Cherwell
DISTRICT COUNCIL
NORTH OXFORDSHIRE

Application Nos.: 21/02337/DISC and 21/02339/REM

Proposal: Discharge of various conditions and reserved matters for first phase of 500 dwellings

Location: Proposed Himley Village North West Bicester
Middleton Stoney Road
Bicester
Oxfordshire

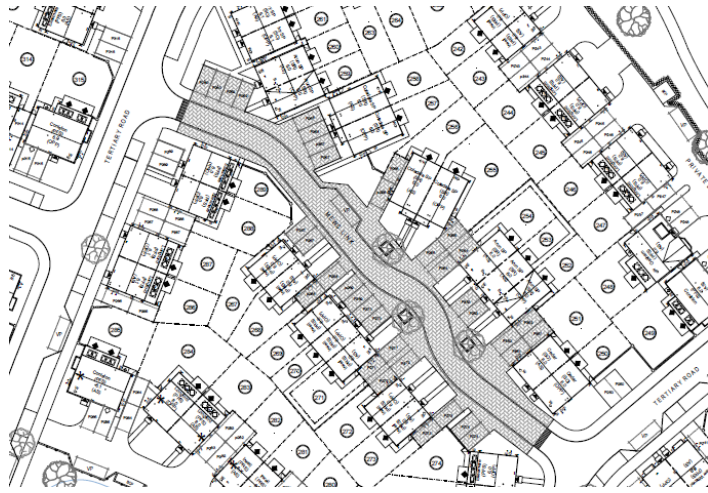
There are also points raised in the formal pre-app response (dated 5 May 2021) which have not been addressed such as:

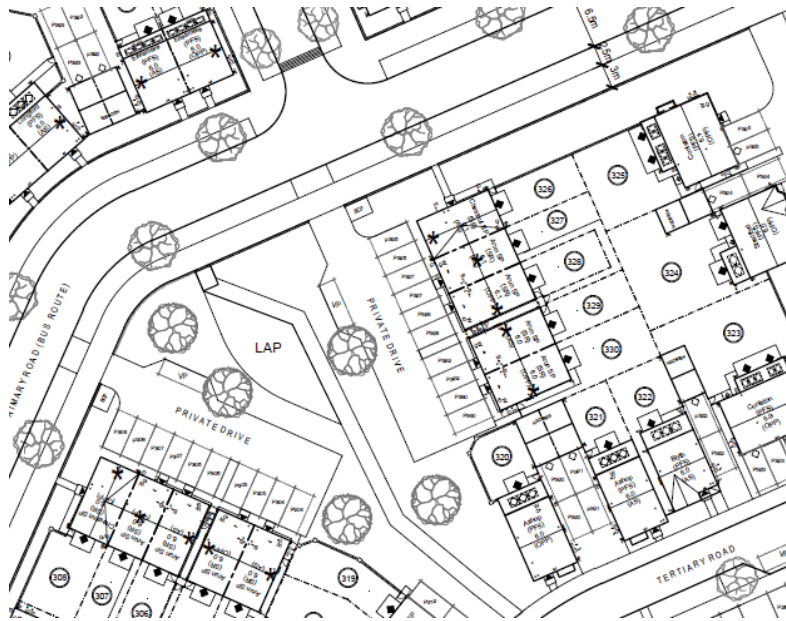
- Notwithstanding the above, street scenes and the Architectural Styles/ Elevations plan are provided, which identify a Georgian approach to the primary and secondary streets. You will note I have queried this approach earlier.
- The layout of plots 440-447 is of concern being tucked away and I feel this area looks distinctly part of the affordable provision on plan.
- The extent of Secondary Street between plots 352-354 and 359-361 is dominated by parking and side boundaries. This does not create a successful street scene.
- There is an overuse of private drives. Why, in this example, is a lane not proposed rather than two private drives?
